Product Change Notification

Change Notification #: 113012 - 00
Change Title: Intel® Spare Power Distribution Board
FUPPDBHC
PCN 113012-00, Product Design
Change Capacitor and Cable
Date of Publication: May 07, 2014

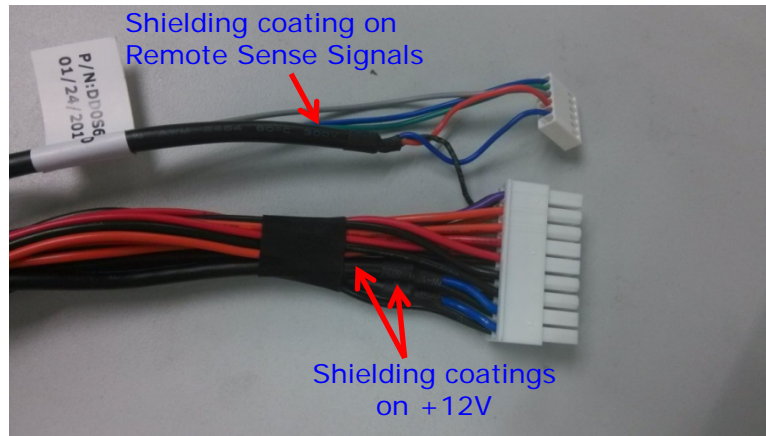
1. Increase the capacitor values of C11 and C13 from 0.1 μ F to 2.2 μ F to extend the duration of the Over Current Protection circuit from 0.6ms to 8.0ms. Please refer to the TA-1056-01 for more details.
